# **Accessibility Survey**

# City of Downey Hondo Street - Rives Avenue To Old River School Road

Date of Inspection 4/13/2017

**Disability Access Consultants**

# Change In Level West Of Richeon Avenue @ 33.930639019662, -118.155583888292

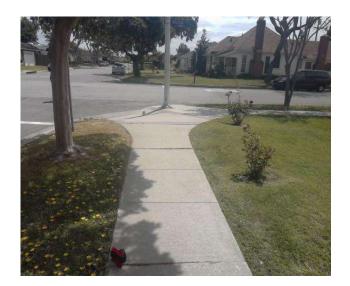
There is a change in elevation greater than recommended value.

**On-Site Finding** 0.50 inches

Ensure that the change in elevation is within the recommended value.

Recommendation Up to 0.25 inches

# Change In Level West Of Richeon Avenue @ 33.931227653420, -118.156440854073

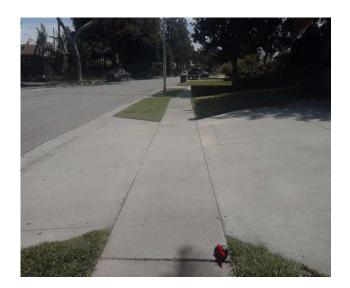
There is a change in elevation greater than recommended value.

**On-Site Finding** 0.75 inches

Ensure that the change in elevation is within the recommended value.

Recommendation Up to 0.25 inches

# Change In Level West Of Richeon Avenue @ 33.931289966018, -118.156566917896

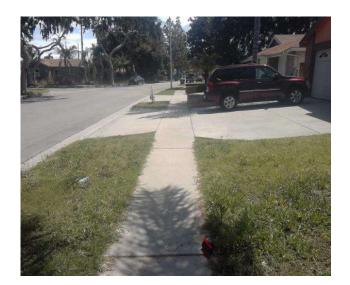
There is a change in elevation greater than recommended value.

**On-Site Finding** 0.62 inches

Ensure that the change in elevation is within the recommended value.

Recommendation Up to 0.25 inches

# Change In Level West Of Richeon Avenue @ 33.931588175679, -118.157151639462

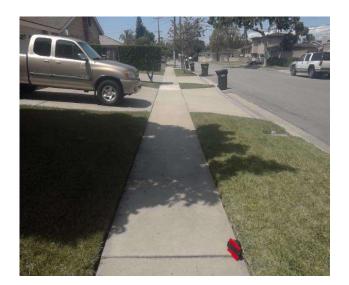
There is a change in elevation greater than recommended value.

On-Site Finding 0.62 inches

Ensure that the change in elevation is within the recommended value.

Recommendation Up to 0.25 inches

# Change In Level West Of Richeon Avenue @ 33.931463550873, -118.156895488501

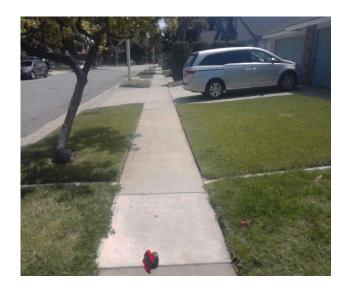
There is a change in elevation greater than recommended value.

**On-Site Finding** 0.37 inches

Ensure that the change in elevation is within the recommended value.

Recommendation Up to 0.25 inches

#### Sidewalk East Of Old River School Road @ 33.932775440352, -118.159208893776

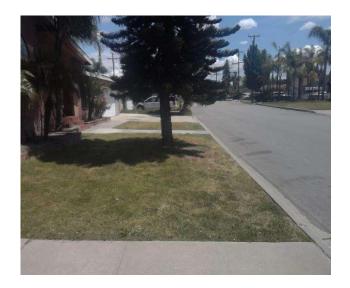
Section of sidewalk is missing and consists of dirt, grass or gravel.

**On-Site Finding** 183.00 feet

Provide a compliant sidewalk for the missing section.

## Sidewalk East Of Pomering Road @ 33.932025473777, -118.157702833414

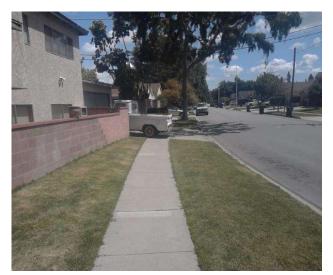
Sidewalk cross slope is not compliant.

**On-Site Finding** 5.30 percent for 112.00 feet

Repave the sidewalk surface with the recommended cross slope.

Recommendation Up to 2.08 percent

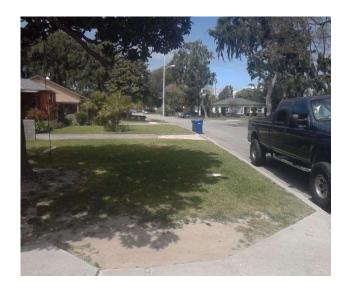
Section of sidewalk is missing and consists of dirt, grass or gravel.

**On-Site Finding** 103.00 feet

Provide a compliant sidewalk for the missing section.

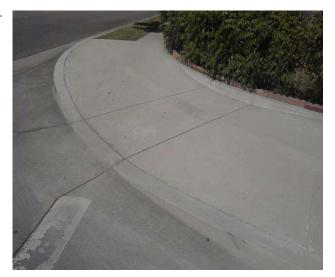
The slope of the curb ramp side flare is greater than allowed.

**On-Site Finding** 11.60 percent

Provide curb ramp side flares with a compliant slope.

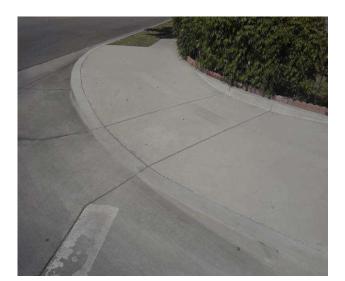
The slope at the top landing is greater than allowed.

**On-Site Finding** 4.40 percent

Provide a top landing surface that does not exceed the maximum slope and cross slope. Provide a sufficient maneuvering clearance that does not accumulate water.

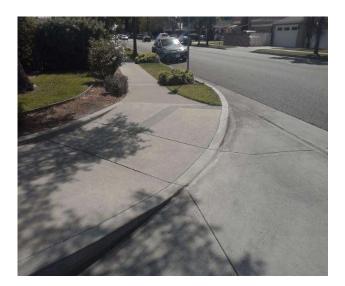
The curb ramp does not provide a detectable warning surface which includes truncated domes.

On-Site Finding Not Found

Provide compliant detectable warnings to surface.

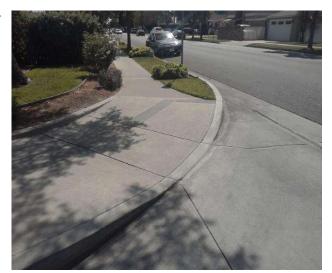
The slope of the curb ramp side flare is greater than allowed.

On-Site Finding 13.20 percent

Provide curb ramp side flares with a compliant slope.

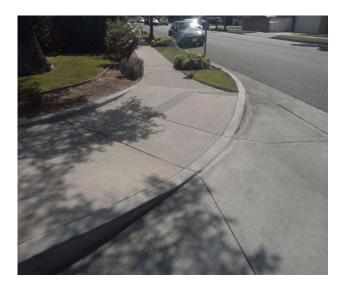
The slope at the top landing is greater than allowed.

On-Site Finding 4.00 percent

Provide a top landing surface that does not exceed the maximum slope and cross slope. Provide a sufficient maneuvering clearance that does not accumulate water.
